**WATER SUPPLY EVALUATION
FOR PROPOSED PROJECTS
ALONG THE I-84 CORRIDOR**

Idaho Power Company

November 14, 2012

Figure 2

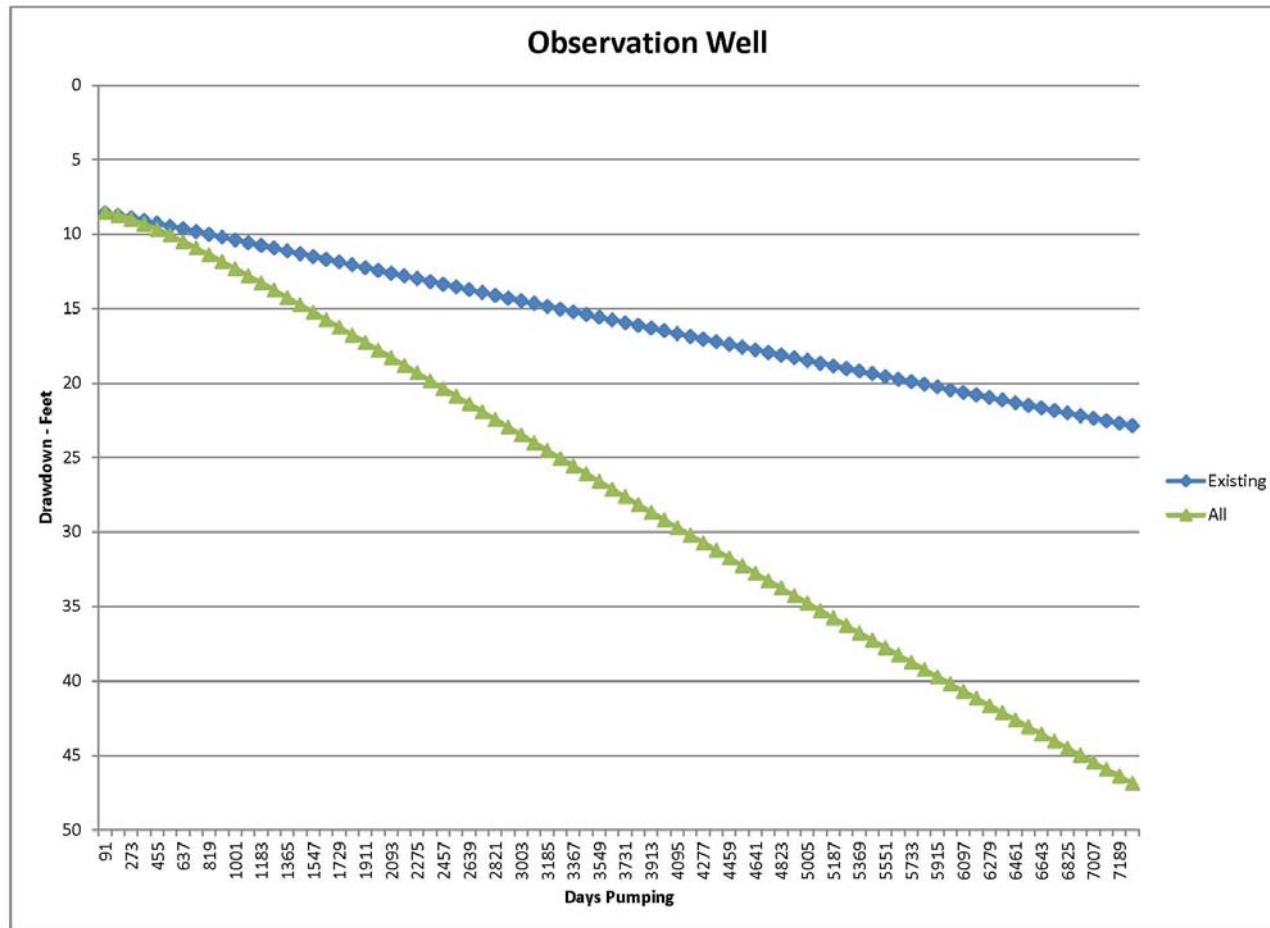
To estimate the impact of continued pumping by existing water users the program was run for an additional 20 years. A simulated observation well was placed near the center of Sec 19 Twp 1S Rge 5E, B.M. which is near the location of the fault identified by Bond and near the boundary of the study area and the comparison area². The results of the additional simulated pumping are shown in Figure 2 below. The analysis shows an estimated drawdown at this location of about 8 feet after 20 years of pumping the existing wells. When pumping of those wells continued for the second 20 years the analysis shows an increased rate of drawdown of about 15 feet for a total drawdown of about 23 feet by existing water uses after 40 years of pumping.

The existing permits, transfers and new water right applications were then added to the analysis and the second 20 year simulation was run a second time. The projected drawdown is shown on Figure 2 below as "All" and shows a drawdown of about 47 feet in the second 20 years, about double the drawdown that is forecast if existing conditions remain unchanged.

Recognizing the Theis analysis is a simplification of the actual conditions that may exist in both the study area and the comparison area, it does point to the potential interconnection between the two areas. Such an interconnection could cause some of the net recharge IDWR identified in the study area to not be available for future appropriations because it is part of the interconnected supply already being used by existing ground water users. It also shows the potential for any new water uses in the

Figure 3

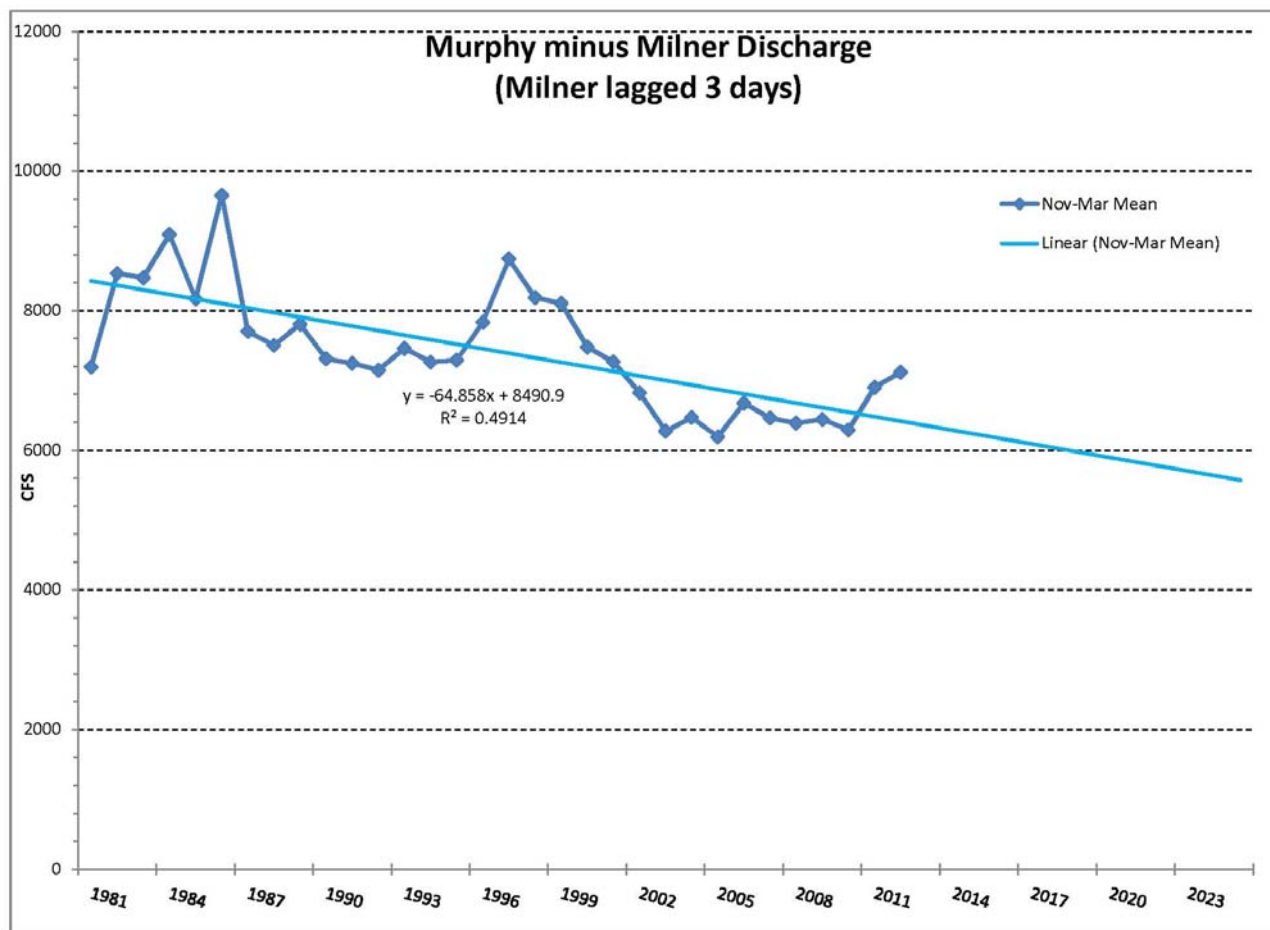
Figures 3 and 4 below were produced using mean daily flows for Murphy and Milner, modified as described above, and averaged for the winter and summer periods respectively. Figure 3 suggests the average mean daily winter discharge at Murphy, as modified above, has declined about 2,000 cfs since 1981 and is continuing to decline at about 65 cfs per year. Projecting this rate of decline forward from 2012 for 13 years suggests the average mean daily flow for the winter of 2025 will be 5,600 cfs, the winter minimum flow established by the Swan Falls Agreement and approved by the Idaho Legislature.

Figure 4

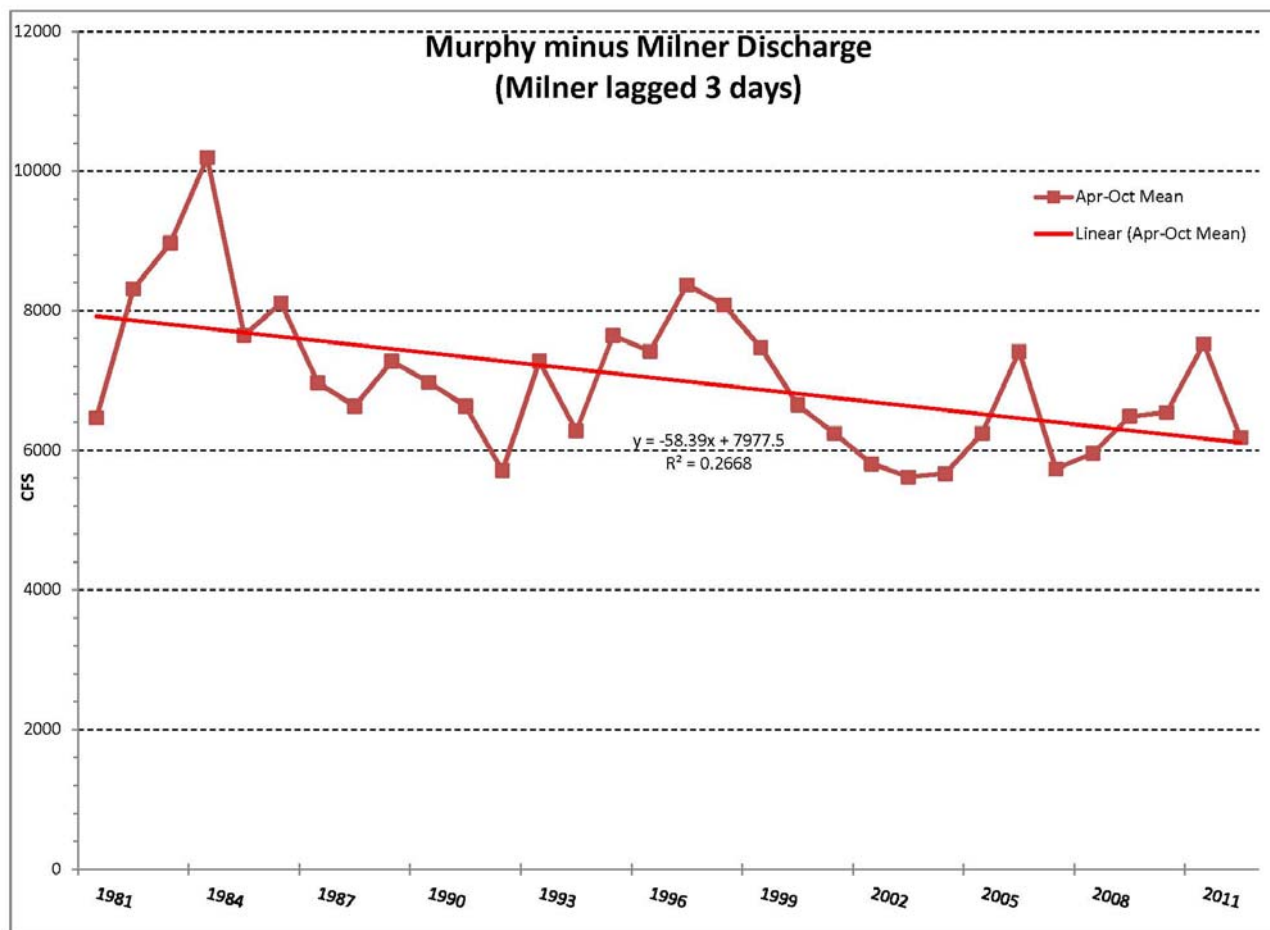
Figure 4 suggests the average mean daily summer discharge at Murphy, as modified above, has declined about 1,850 cfs since 1981 and is continuing to decline at about 58 cfs per year. The average summer flows are still high enough there is no immediate danger the entire average summer flow will decline to 3,900 cfs, the summer minimum flow established by the Swan Falls Agreement and approved by the legislature. Summer flows are, however, quite variable, and time periods shorter than the 7 months from April through October were examined to determine if one period was consistently lower than the entire summer period. To perform that analysis, monthly averages of mean daily summer flows at Murphy, as modified, were calculated for the months April through September with the lowest month being July.
